Ravensworth Composting Facility | State Significant Development | Modification 3

SUBMISSIONS REPORT

Prepared for Bettergrow Pty Ltd (Bettergrow) | 23 July 2026

Figure 3.1
Predicted incremental 99th percentile average odour concentration contours

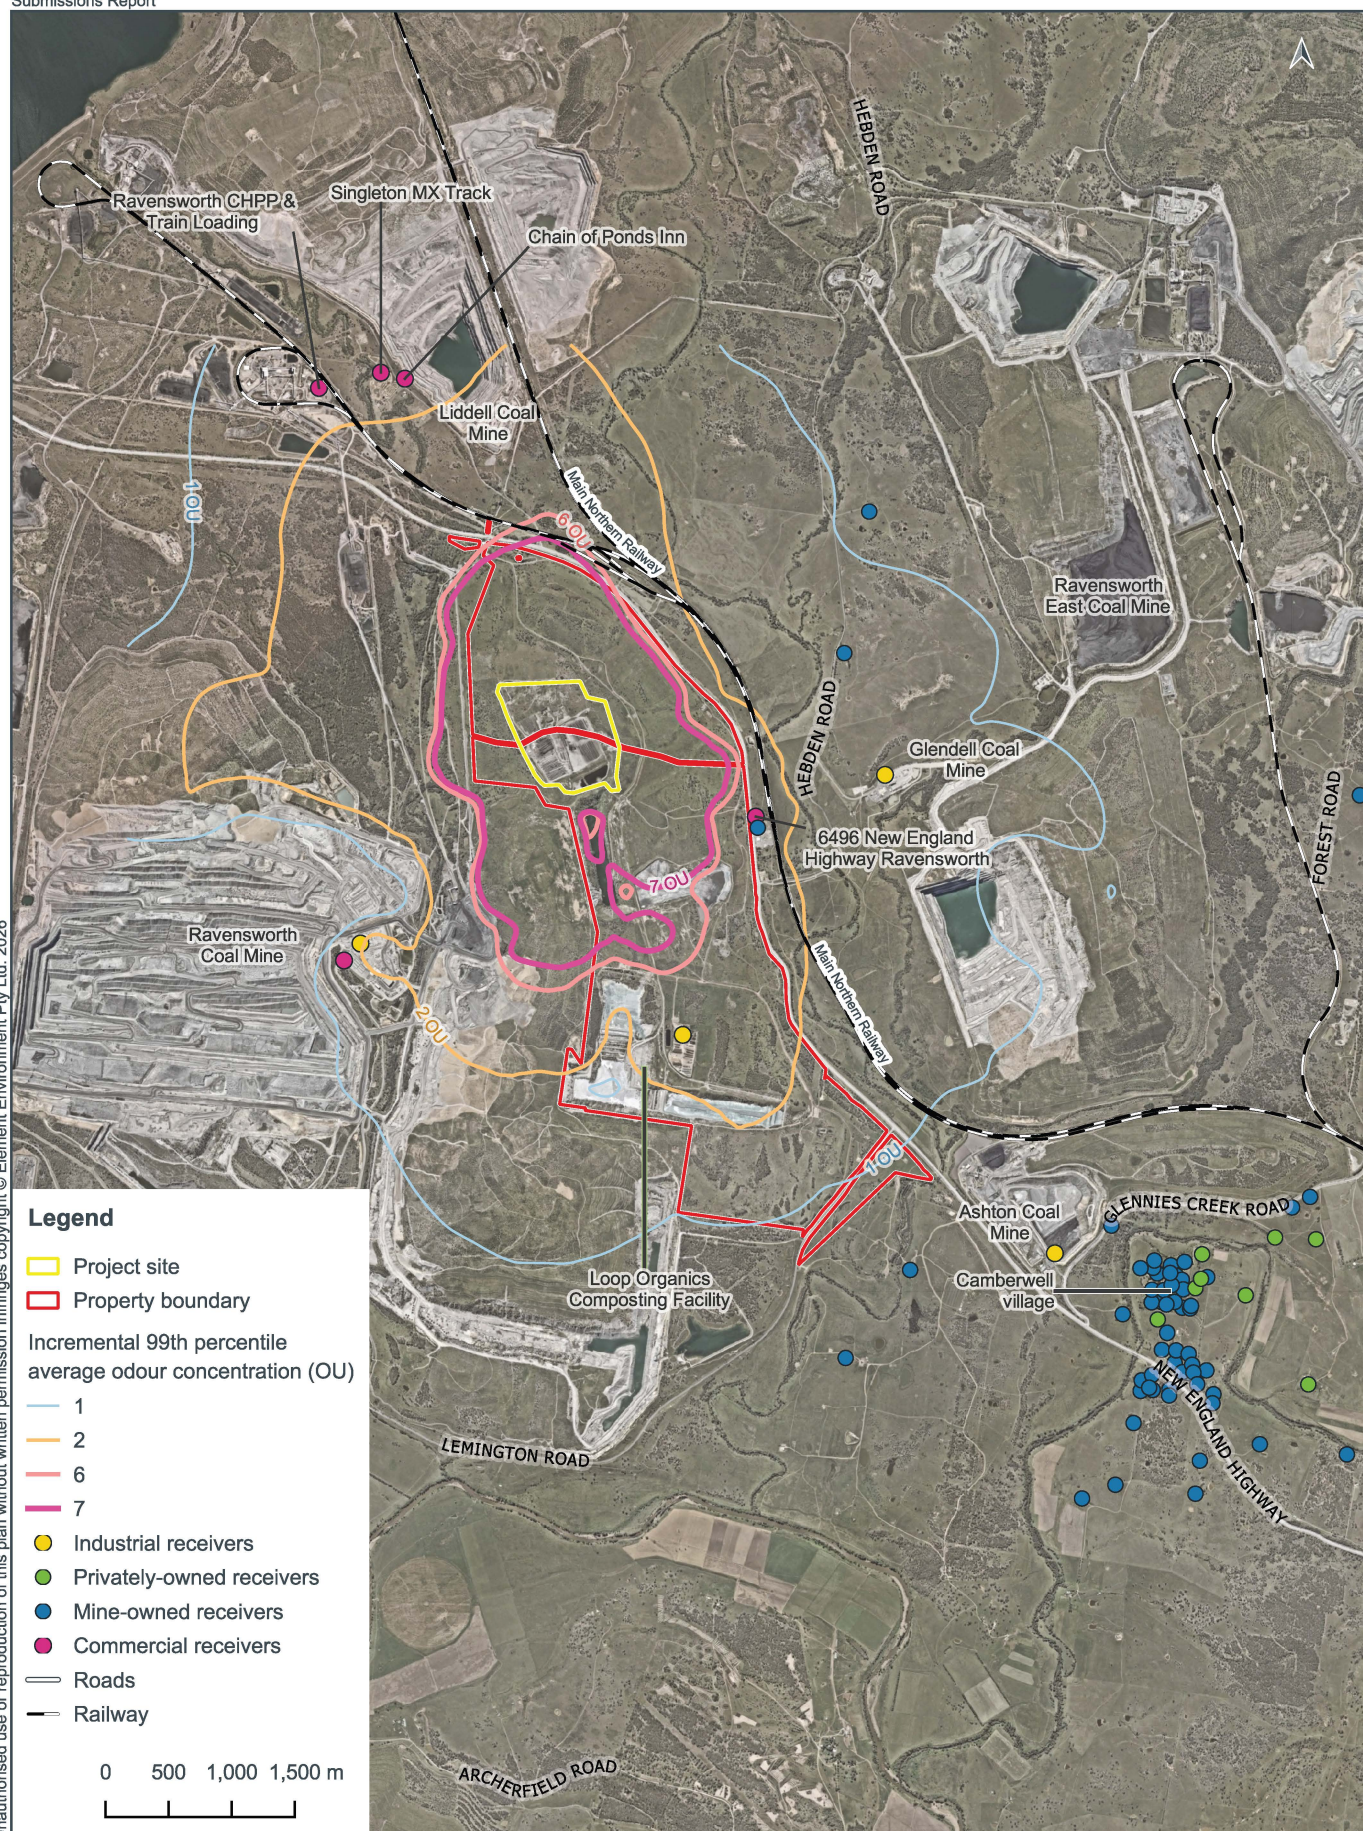
Bettergrow response:

The predicted incremental 99th percentile average odour concentrations for the project at the nearest sensitive receivers are shown in Figure 6.2 of the Modification Report, and the predicted cumulative 99th percentile average odour concentrations for the project at the nearest sensitive receivers are shown in Figure 6.3 of the Modification Report. These figures have been updated and reproduced in Figure 3.1 and Figure 3.2 below to show the predicted incremental and cumulative 99th percentile average odour concentrations for the project at the nearest industrial, commercial, mine-owned and privately-owned receivers.

The modelling results indicate that incremental and cumulative odour levels during operation of the project would be well below the most stringent NSW EPA impact assessment criterion of 2 OU at the majority of the nearest sensitive receiver locations, including all of the nearest mine-owned and privately-owned receivers (refer to Figure 3.1 and Figure 3.2).

Figure 3.2
Predicted cumulative 99th percentile average odour concentration contours

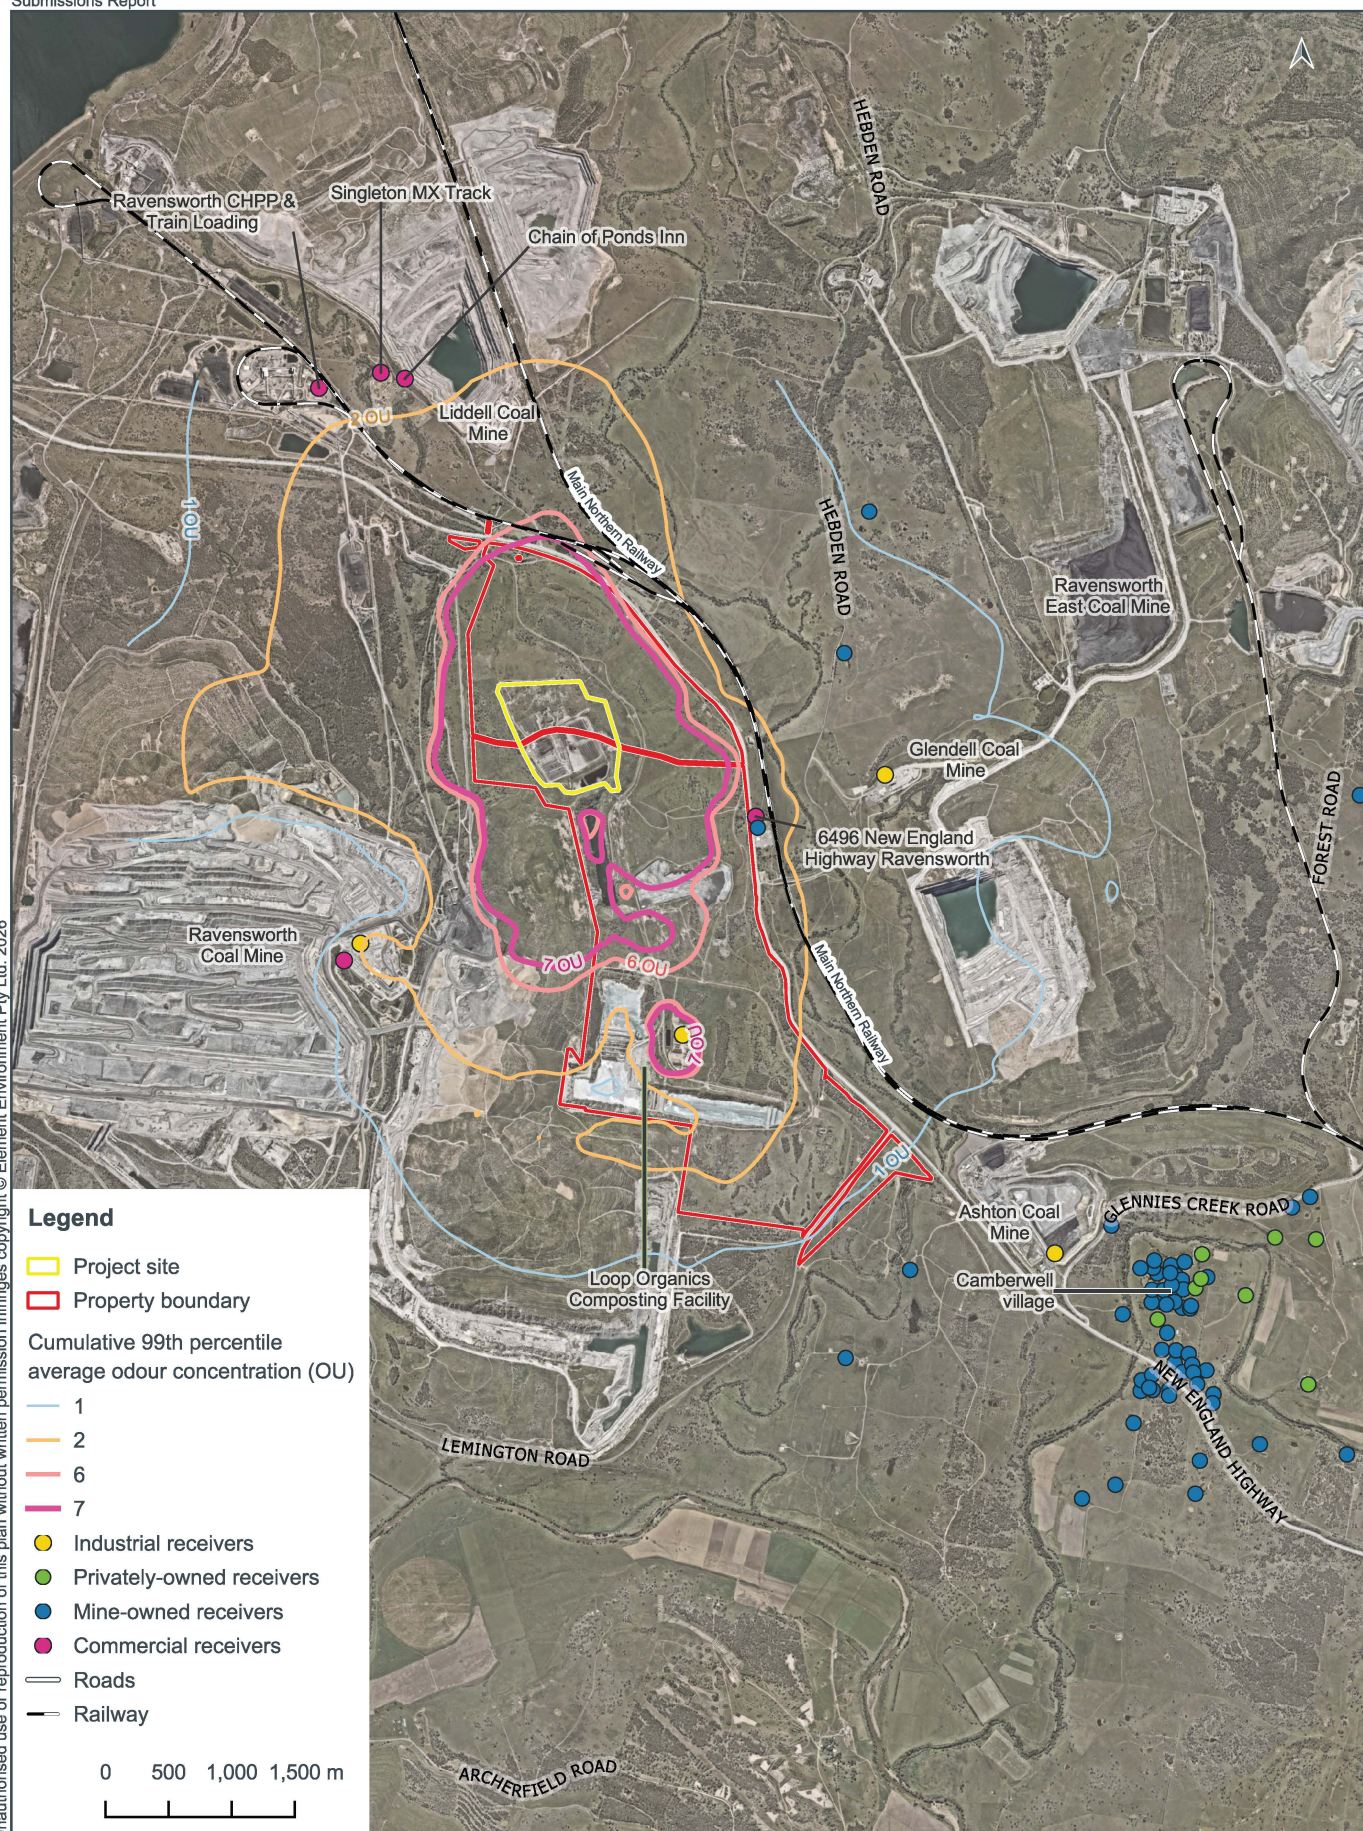
Bettergrow response:

Loop Organics has recently received approval from Council to increase their facility's processing capacity from 55,000 tpa to 95,000 tpa (DA 8.2016.173.8). As the development application for this proposal was lodged after this modification application, the details of the development application could not be considered in the AQIA. Bettergrow has contacted Loop Organics on several occasions to request further details about the planned expansion, however no information has been received from Loop Organics at the time of writing.

Without specific information on the existing and proposed process activities, material types, operational practices, active composting areas, emission controls and odour emission rates at Loop Organics, any alternative assumptions would be speculative and inconsistent with those for approved projects in the planning system. On this basis, the adopted approach is considered appropriate for assessing potential cumulative odour impacts associated with the project.

Figure 3.3
Updated site layout

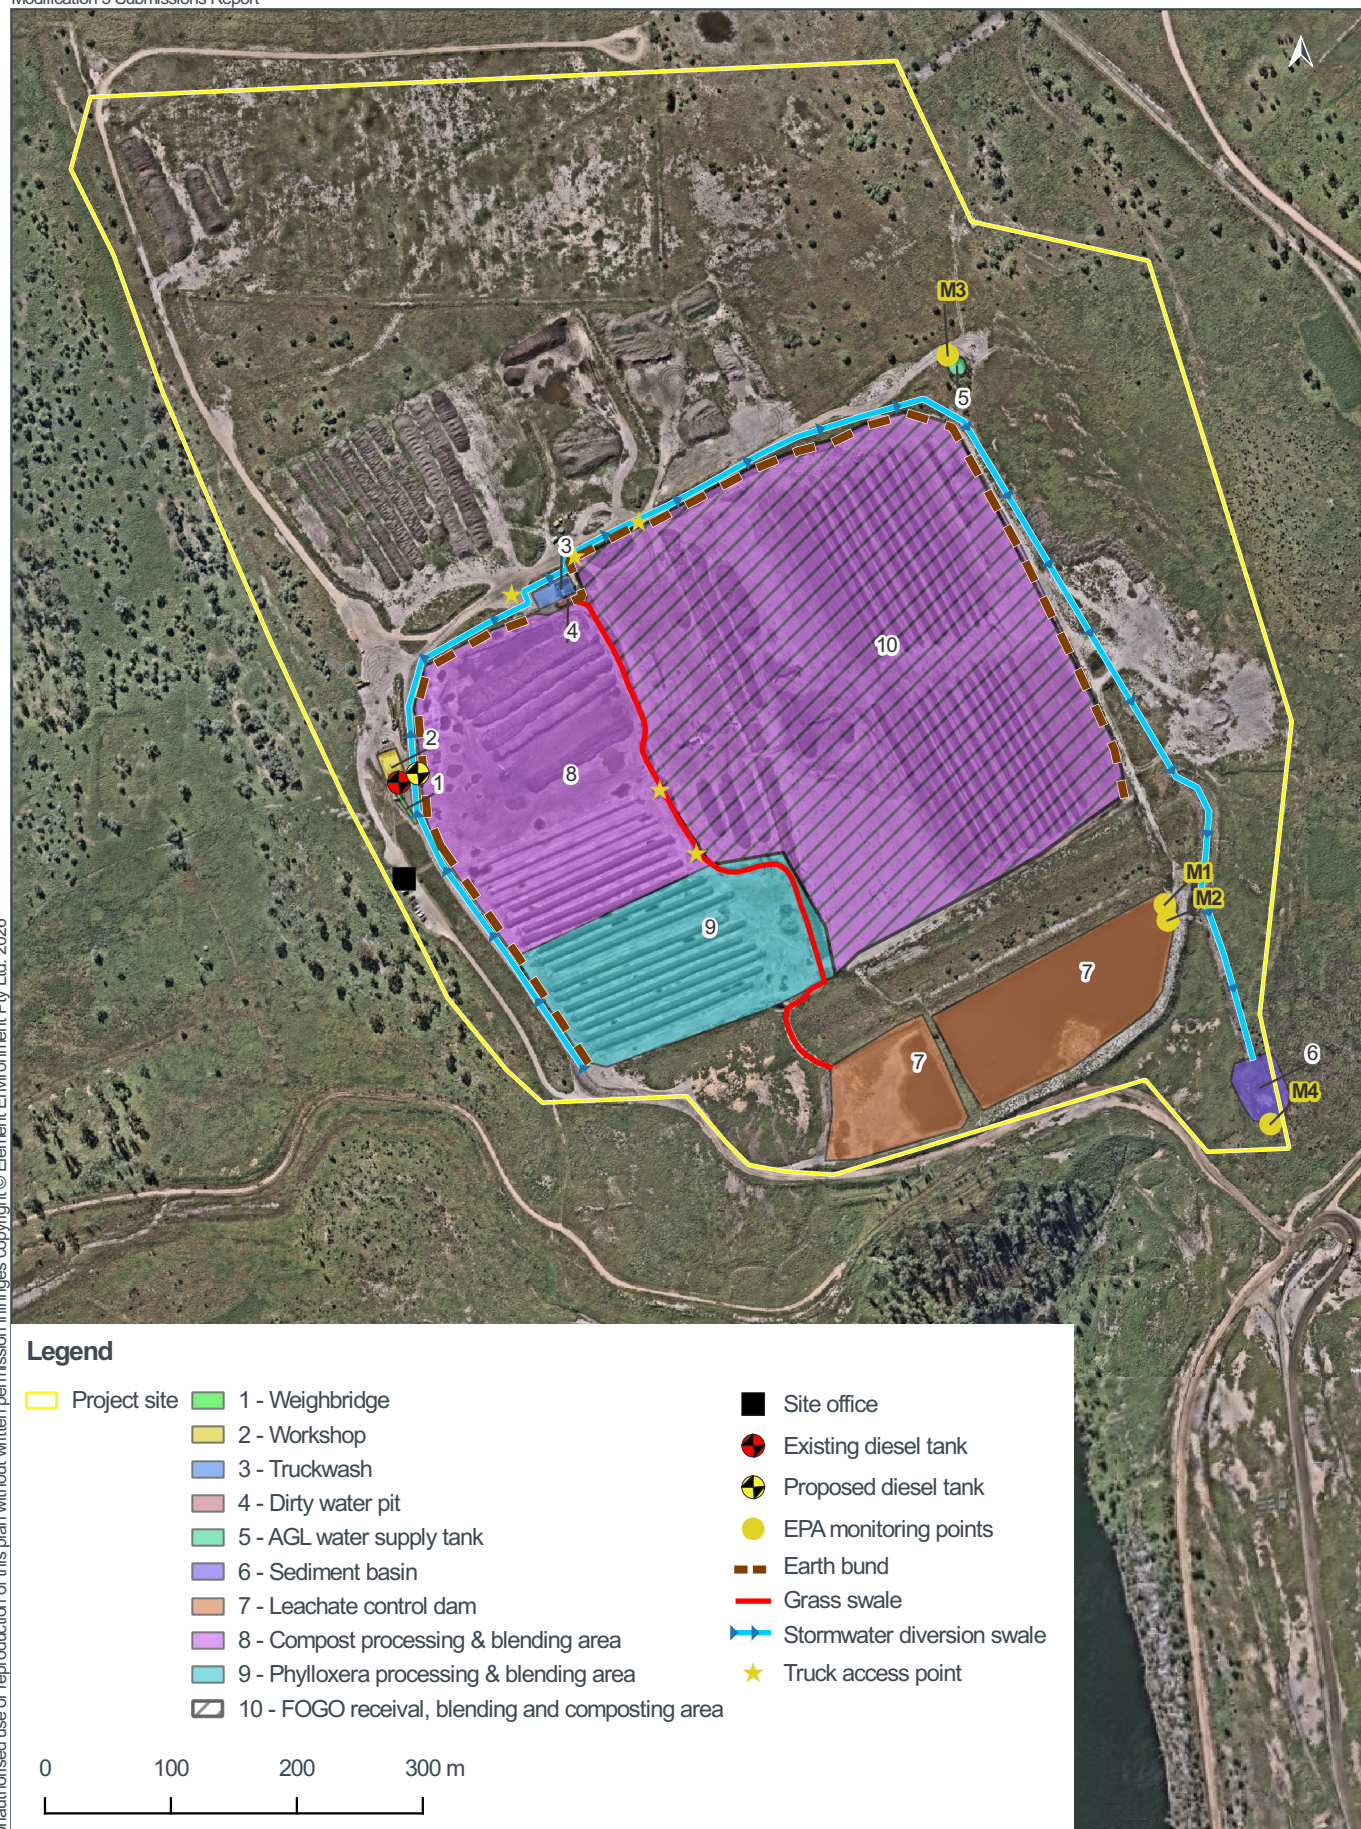
The EPA notes that in the SWIA several potential risks to surface water quality and contamination were identified at the premises. Figure 5-1 of the SWIA shows the outline of the clean water drainage alignment with a number of potential contamination risks, as follows:

Figure 1.5 of the Modification Report, on which Figure 5-1 of the Surface Water Impact Assessment (SWIA) (Appendix D of the Modification Report) is based, has been updated and reproduced as Figure 3.3 below, to provide more detailed information about the existing surface water and leachate management controls at the site to minimise potential contamination risks at the facility.

The northern stockpile area (refer to Figure 3.3) is a self-bunded (earthen bund) temporary storage area for finished AGL compost product awaiting collection. Rainfall within this area, including during periods of heavy rainfall, dissipates naturally through seepage loss (rainwater infiltrates the compost stockpile into the underlying ground) and evaporation (rainwater evaporates from the surface of the stockpile). There is no runoff from this area into the clean water drainage system.

Diversion bunds are in place along the processing pad perimeter to exclude minor upstream catchment flows from entering the processing pads, as described in Section 1.3.5 of the Modification Report. Grassed swales are also in place along the processing pad perimeter to collect and convey clean stormwater runoff towards the sediment basin, reduce flow velocities and promote evaporation and infiltration, as shown in Figure 3.3. All water, including rainfall, that falls onto the pad is collected and managed as leachate, with the pad graded to convey leachate to the leachate dam.

The eastern clean water drainage line is discontinuous in three locations to allow delivery trucks and plant to access the processing pad for operational purposes, as shown in Figure 3.3. The grass swale that conveys wastewater from the truck wash to the leachate dam, is also discontinuous in two locations to enable operational vehicles and plant to travel between the eastern and western processing pads, as shown in Figure 3.3. Culverts have been installed beneath these access points on the processing pad to maintain flow within this swale.
